*PARCEL:	
*OWNER/APPLICANT:	
PERMIT #:	
PROJECT:	HOME OF MY OWN - 3 BED RIGHT (2020 PLANS)

Single-Family Housing
THREE BEDROOM / TWO BATH - RIGHT PARKING
for

YAVAPAI COUNTY BUILDING DEPT.
() REVIEWED FOR CODE COMPLIANCE
() REVIEWED AS NOTED WITH CORRECTION
☒ ENGINEERING REVIEWED FOR DESIGN CRITERIA ONLY
THE ISSUANCE OF A PERMIT BASED ON PLANS, SPECIFICATIONS, AND OTHER DATA, SHALL NOT PREVENT THE BUILDING OFFICIAL FROM THEREAFTER REQUIRING THE CORRECTION OF ERRORS IN SAID PLANS, SPECIFICATIONS, AND OTHER DATA, OR FROM PREVENTING BUILDING OPERATIONS BEING CARRIED ON THEREAFTER, WHEN IN VIOLATION OF THIS CODE OR ANY OTHER ORDINANCES OF THIS JURISDICTION - SEC. 105.4
PLANS EXAMINER: [Signature] DATE

FOUNDATION PLAN
SCALE: 1/4" = 1'-0"

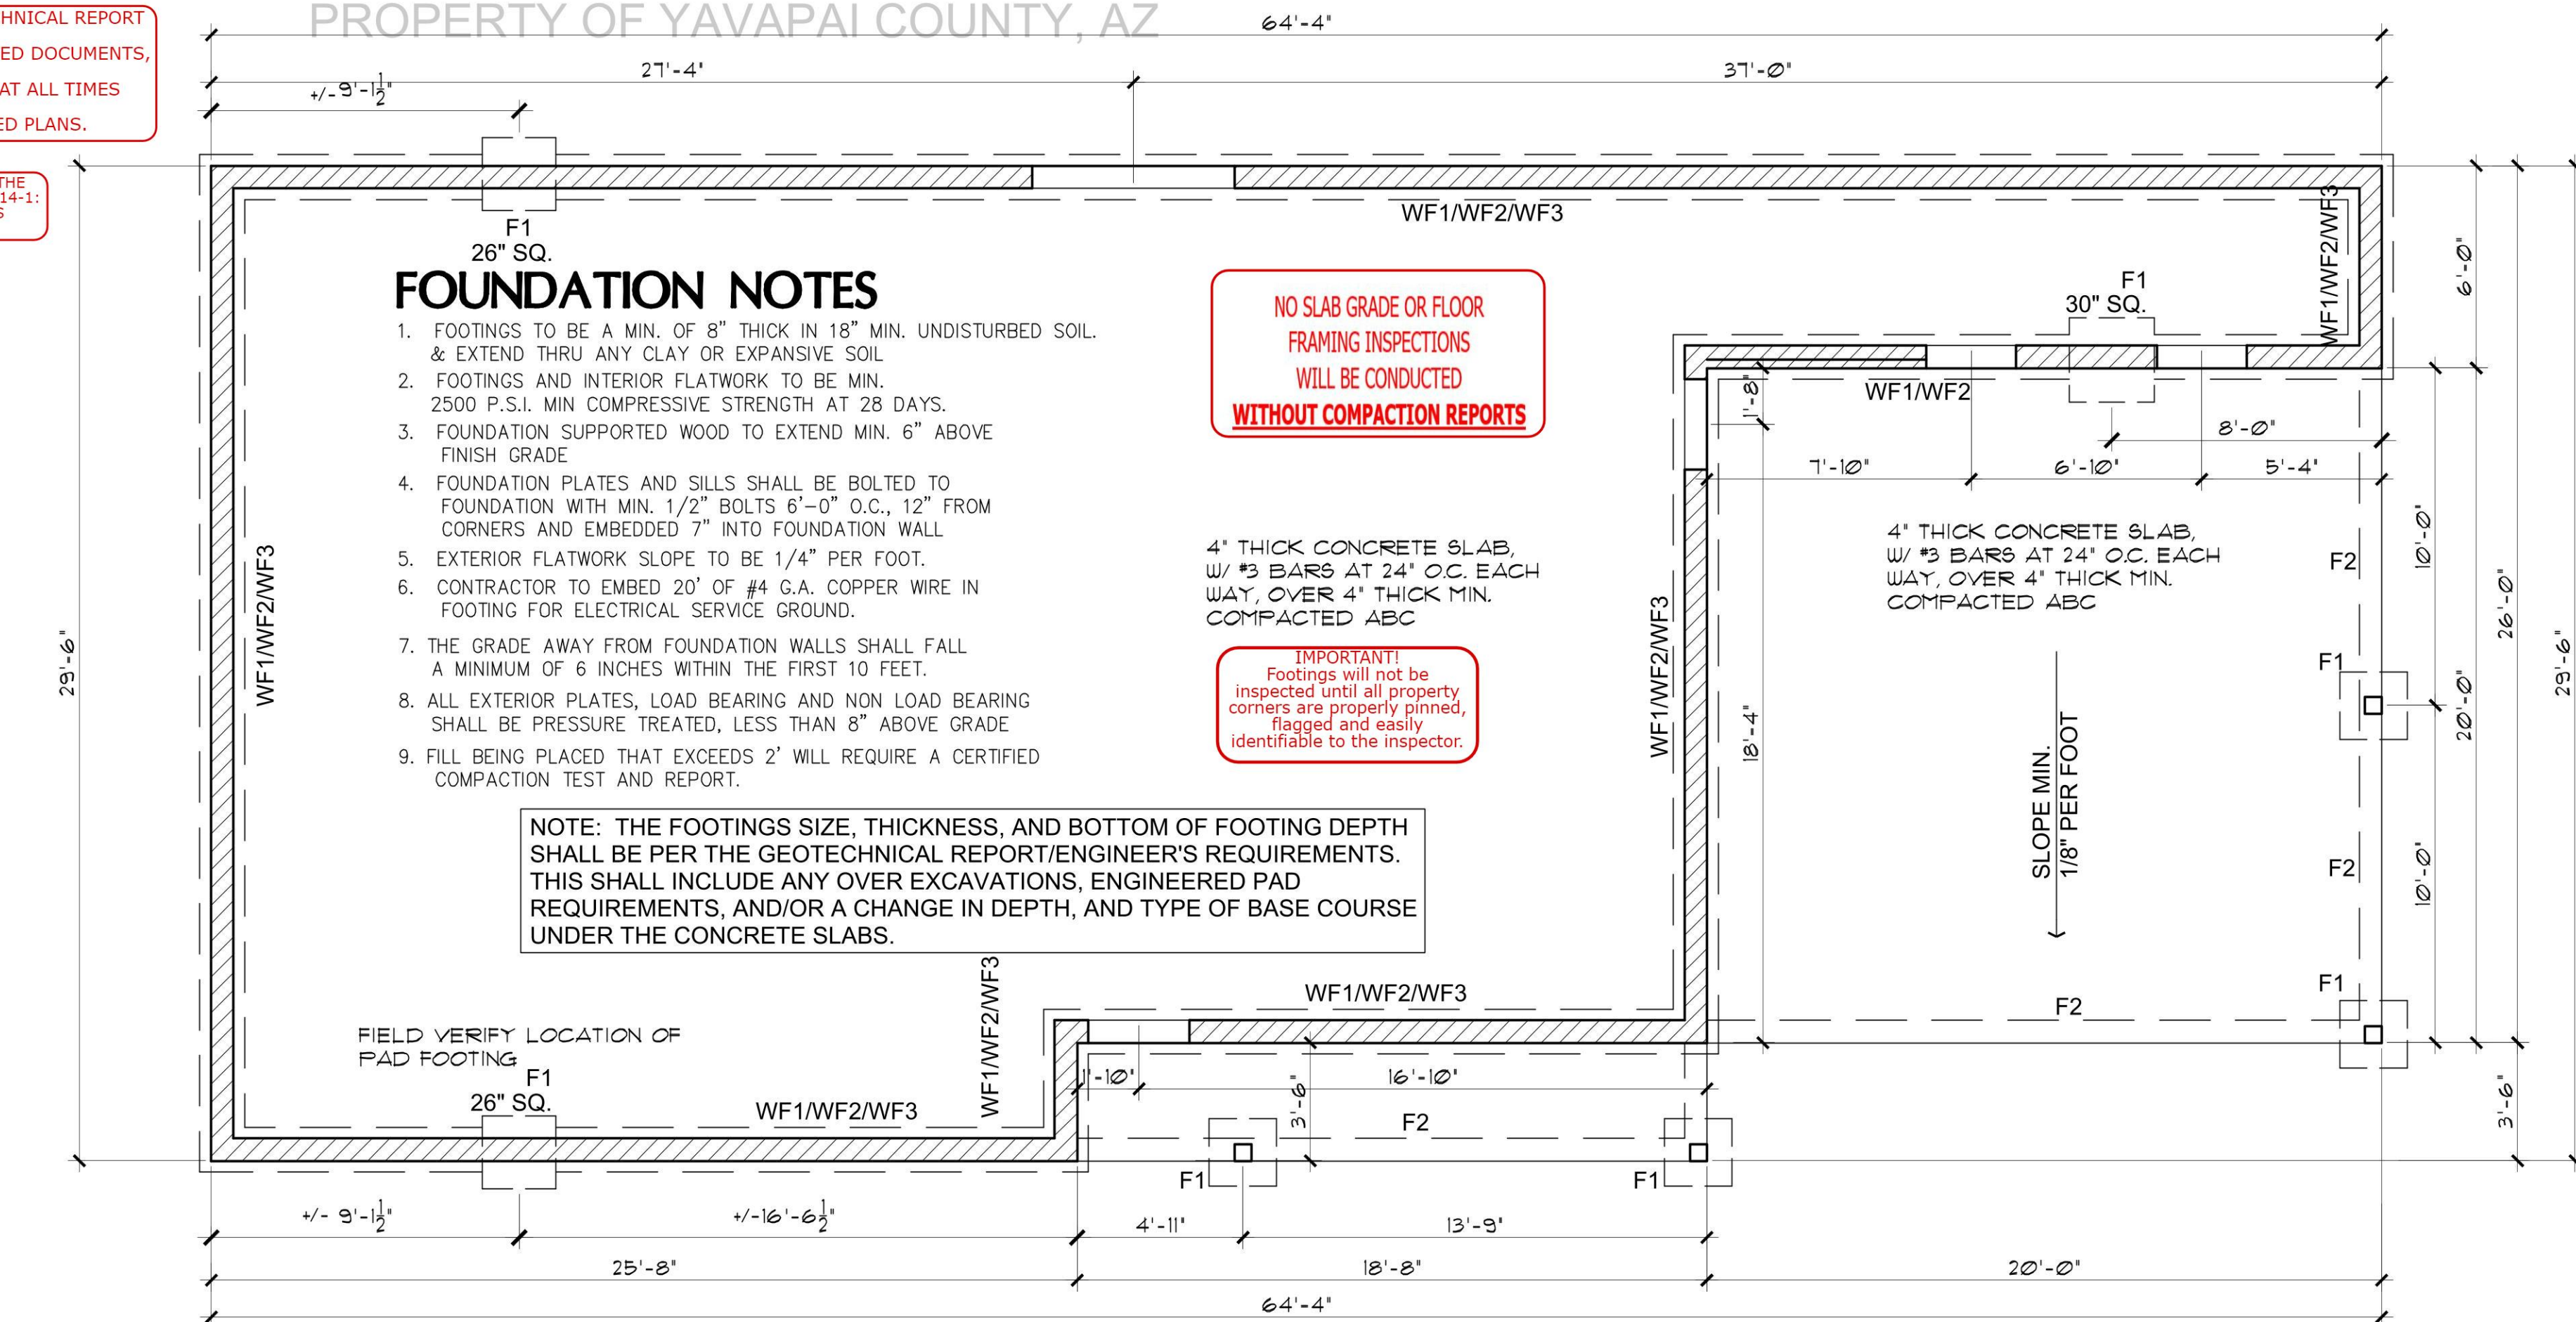
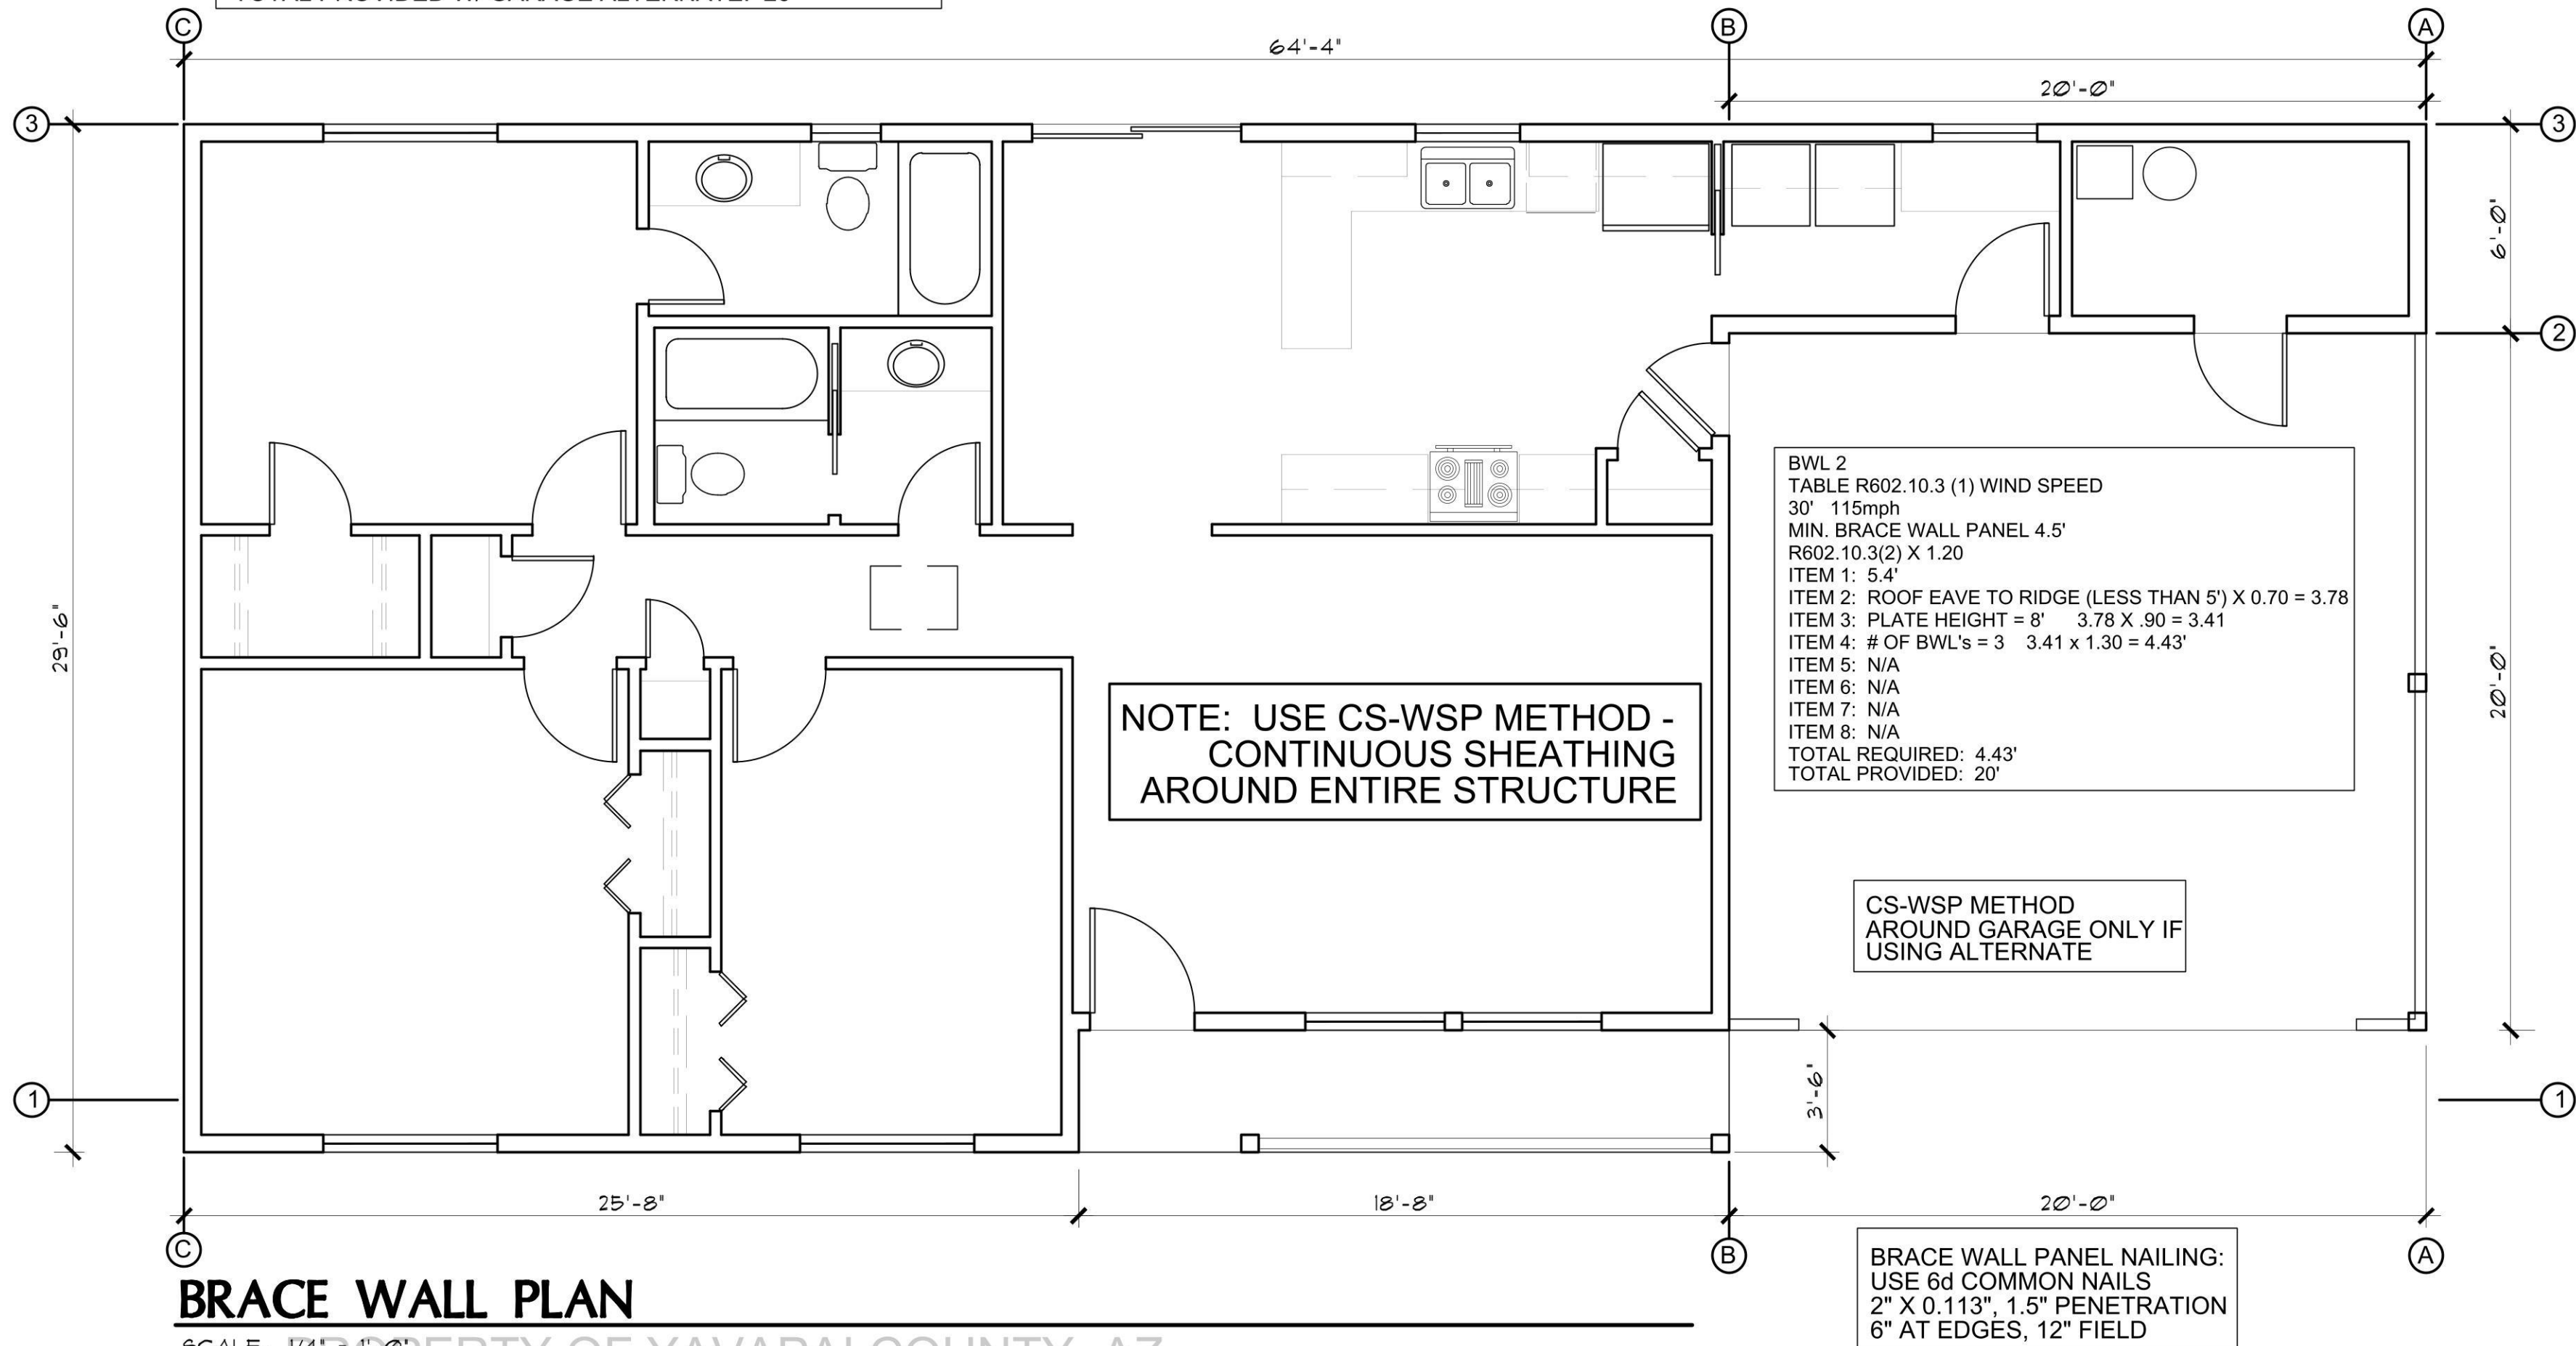
PER SECTION 110.3.4 OF THE
2018 YACBC ORDINANCE 2014-1:
PRE-SLAB INSPECTIONS
ARE REQUIRED

NO SLAB GRADE OR FLOOR
FRAMING INSPECTIONS
WILL BE CONDUCTED
WITHOUT COMPACTION REPORTS

IMPORTANT!
Footings will not be
inspected until all property
corners are properly pinned,
flagged and easily
identifiable to the inspector.
